Product Change Notice (PCN)

PCN Number: PCN-0374226R-01

- CPE 1785

❖ Appearance

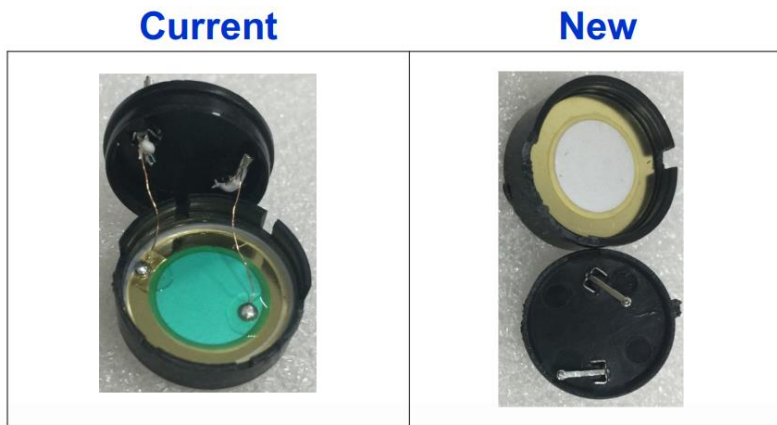
- Case markings Change from NORYL case to PBT
- Bottom notches going from 6 to 2

❖ **Inside structure**

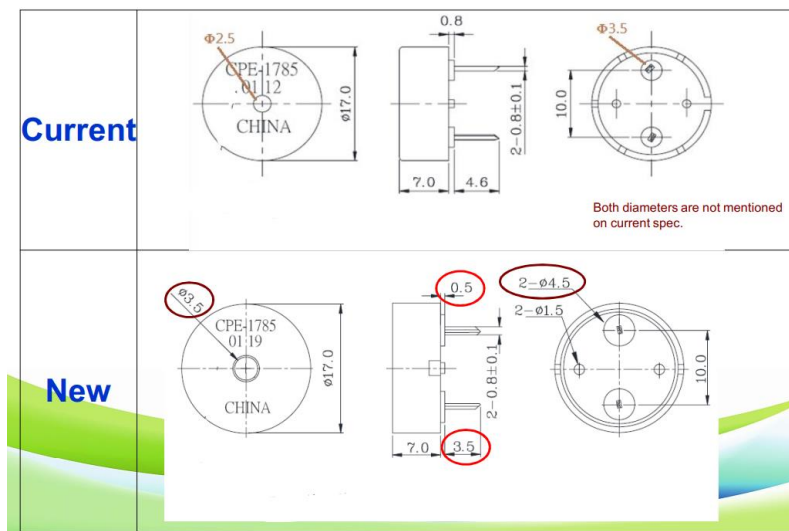
- **Change from solder mask on inside to spring contact**

- ❖ **Pin length from 4.6mm to 3.5mm**
